LAKE PONTCHARTRAIN, L.A.
AND VICINITY
**LAKE PONTCHARTRAIN
HIGH LEVEL PLAN**

**DESIGN MEMORANDUM NO. 20
GENERAL DESIGN**

**ORLEANS PARISH
JEFFERSON PARISH
17th. St. Outfall Canal
(Metairie Relief)**

CELMV-ED-PG (CELMN-ED-SP/15 May 90) (1105-2-10c) 3d End
Mr. Eckenrod/ts/5925
SUBJECT: Lake Pontchartrain, Louisiana and Vicinity, High Level Plan, Design
Memorandum No. 20 - General Design, 17th Street Outfall Canal

ENCL. 25

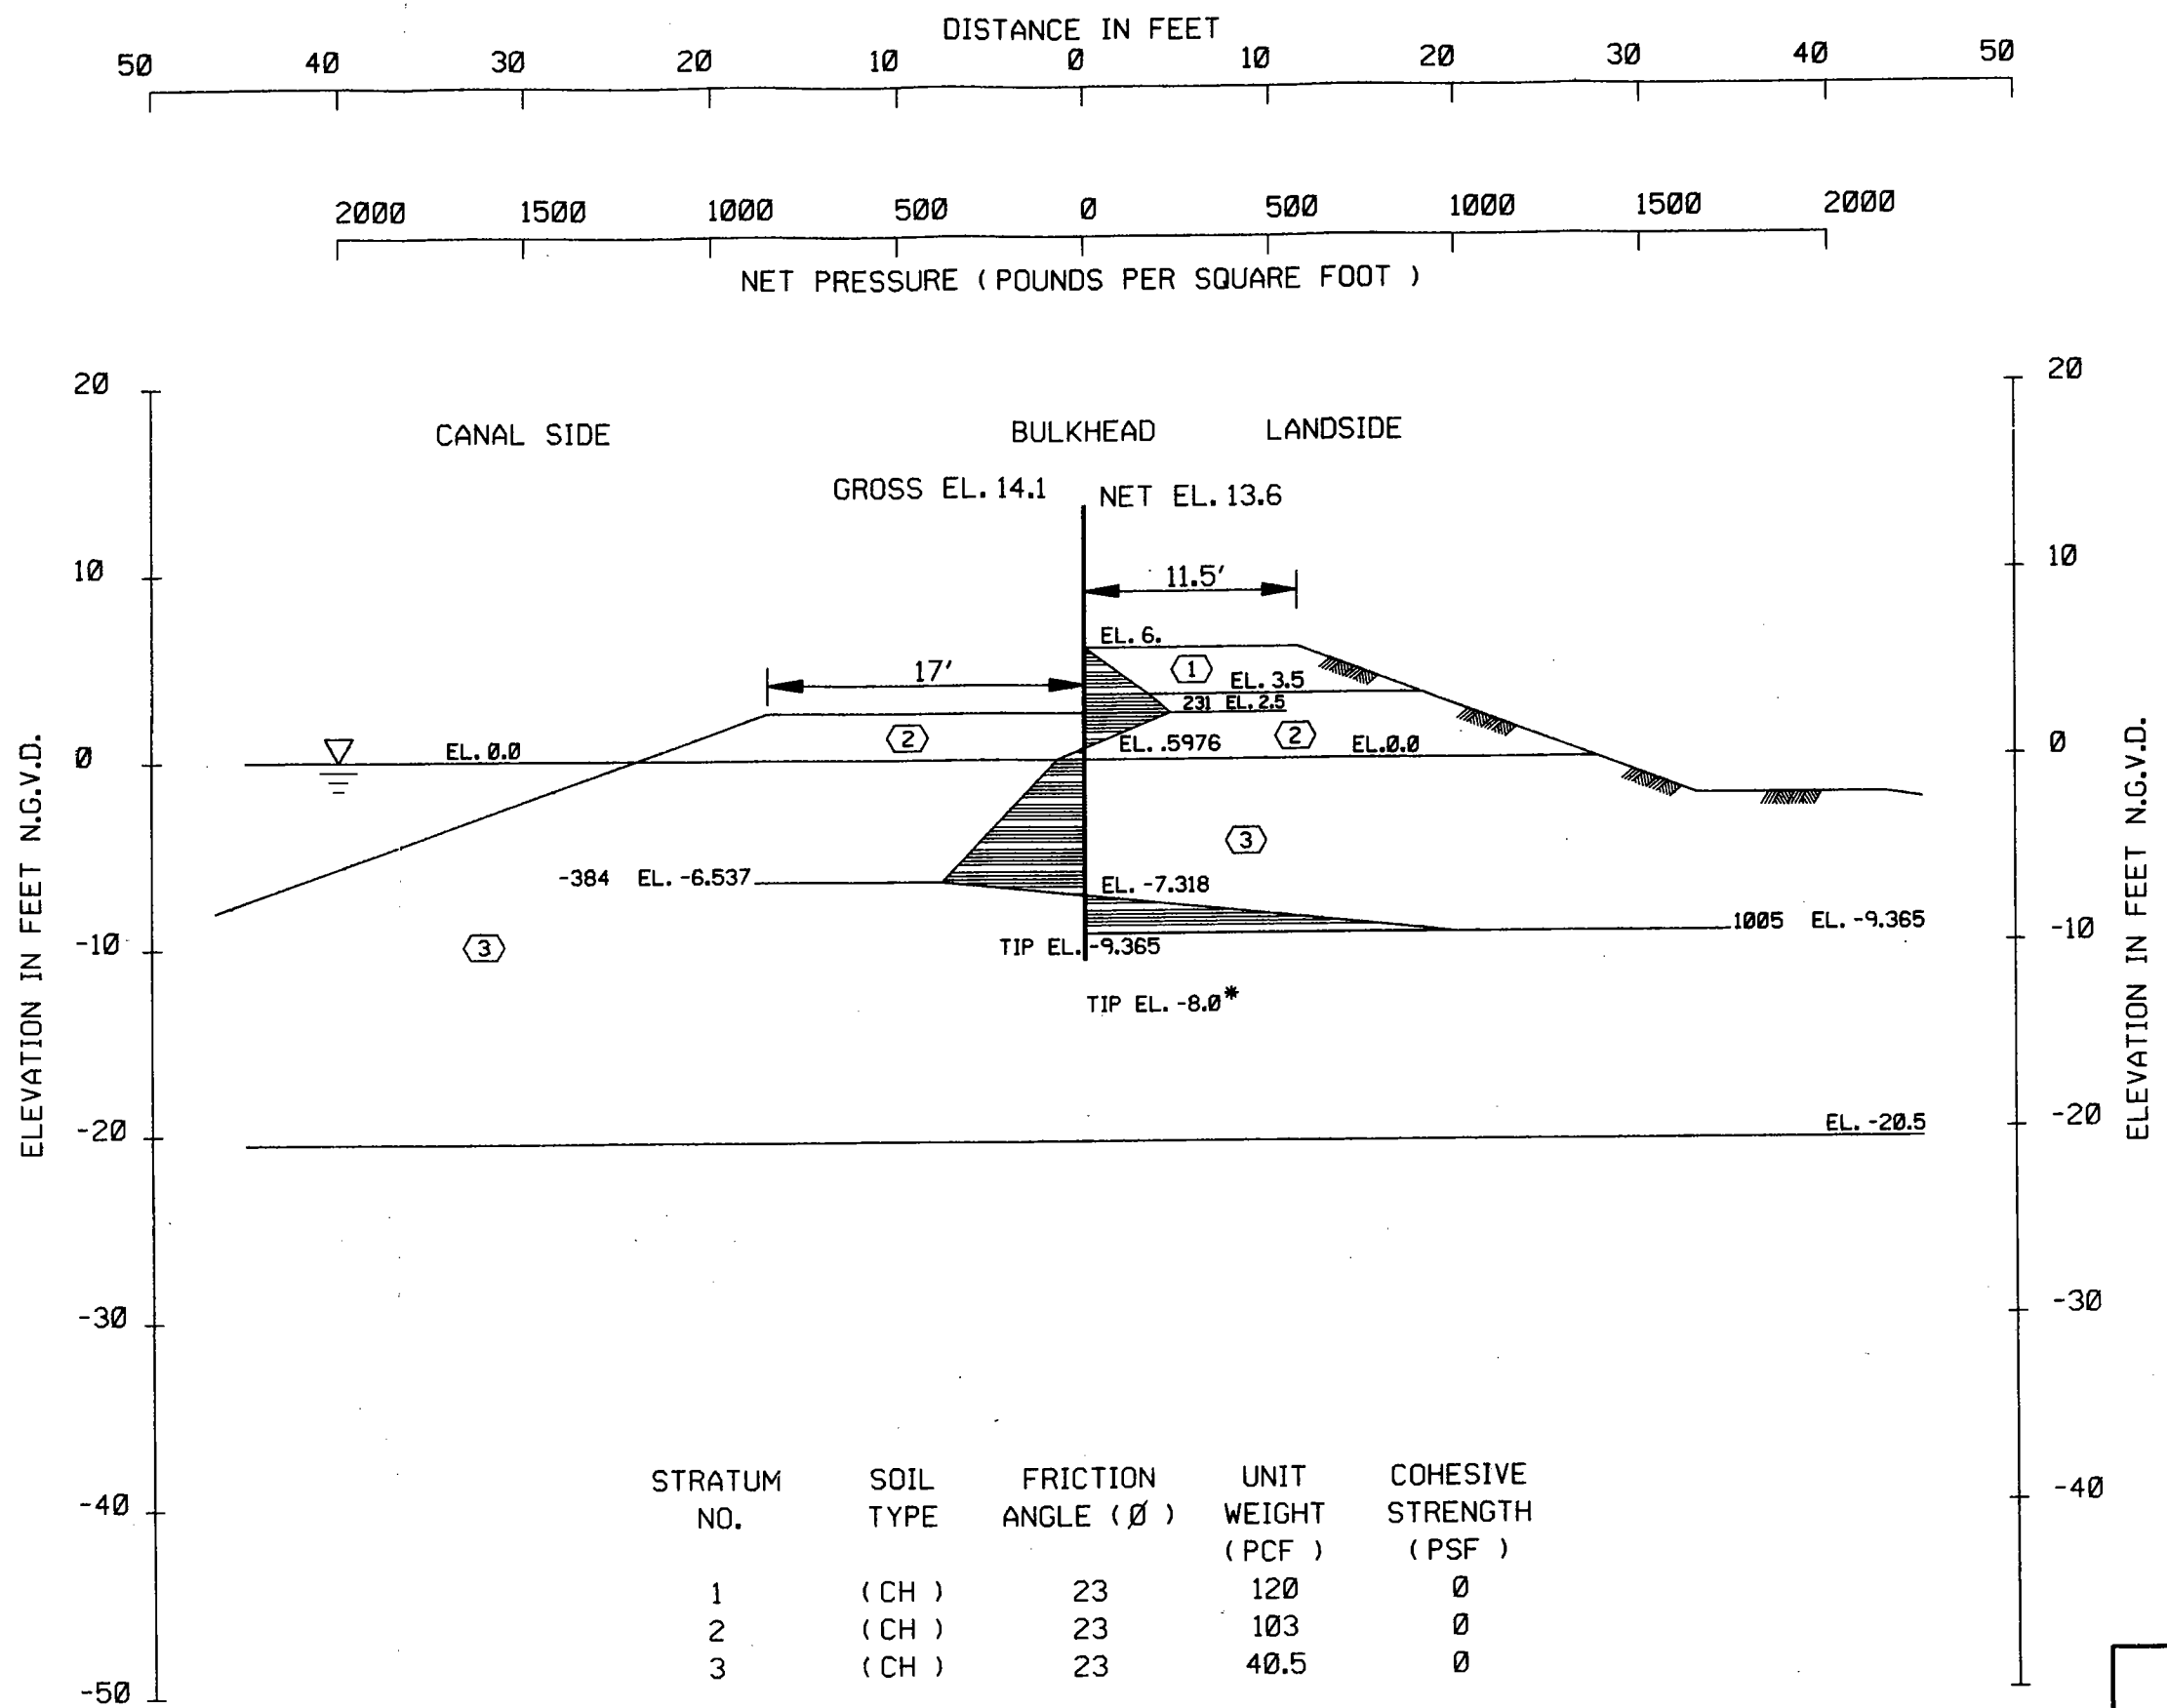
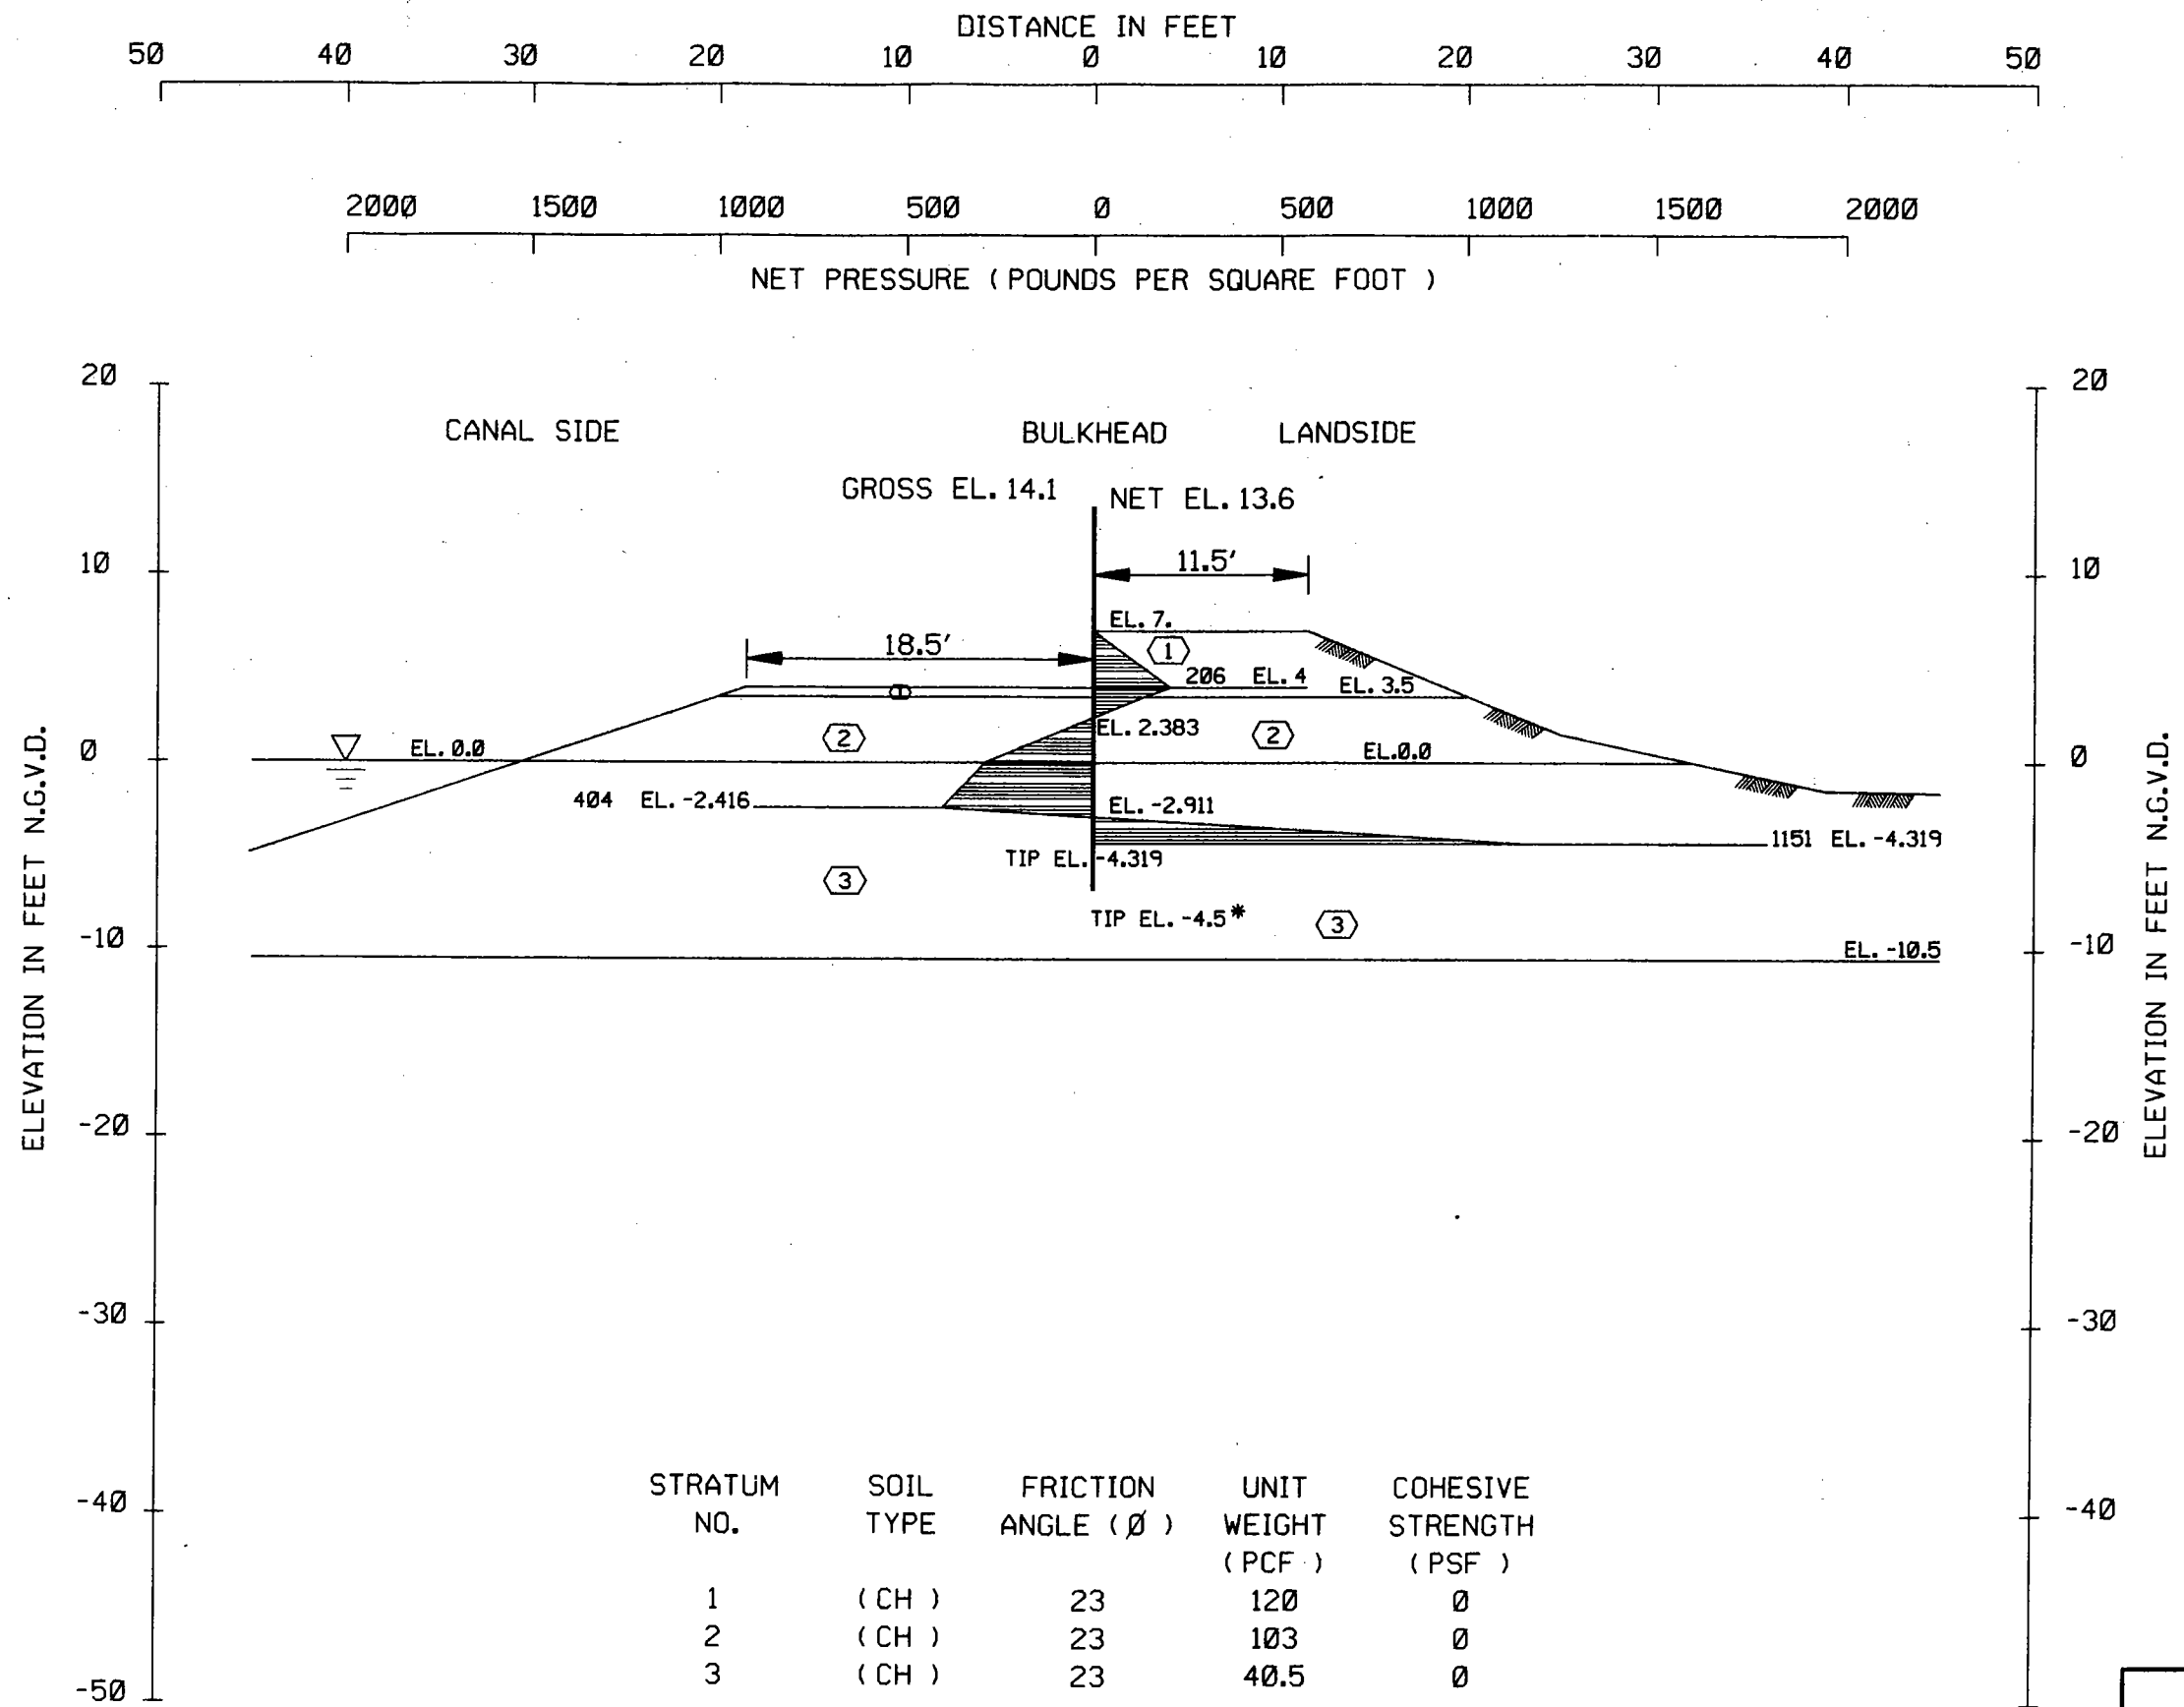
d. Para 29c. Also refer to the tied back and braced wall analyses on Plates 121-124. These analyses are based on the "Q" case soil strengths, a canal level at el -5.0, and a factor of safety of 1.5. Since these sheet pile bulkheads permanently retain soil, they should also be analyzed using "S" soil strengths, a factor of safety of 1.5, and at the normal canal level of el 0.0.

m. Plates 121 through 124. The walls shown on these plates should be evaluated for the anchor forces and resulting stresses on the anchors and the sheet piling should be checked using the conditions shown except change the water level on the canal side to el 0.0 NGVD and use soil properties for the 'S' case and a F.S. = 1.5.

d. Comment d. Para. 29c. The analyses presented were for the Q-CASE soil strengths, a canal level at EL. -5.0 and a factor of safety of 1.5. For plates 121, 122, and 124 the actual design (completed before Dec 87) was controlled by the S-CASE, F.S. = 1.5, and canal level at EL -5.0. The design on plate 123 (completed after Dec 87) was based on the S-CASE F.S. = 1.2 with canal level at EL -5.0; S-CASE F.S. = 1.5 with canal level at EL 0.0; or the 3:1 penetration to head ratio. All the braced walls and tieback walls have been constructed. The tip penetrations shown on plates 122-124 are deeper than the minimum required tip penetration (Encl 3). Intermediate tip penetrations were used to reduce the anchor forces.

m. Comment m. Plates 121 through 124. Concur. Revised plates 121 through 124 are enclosed as Encl 3.
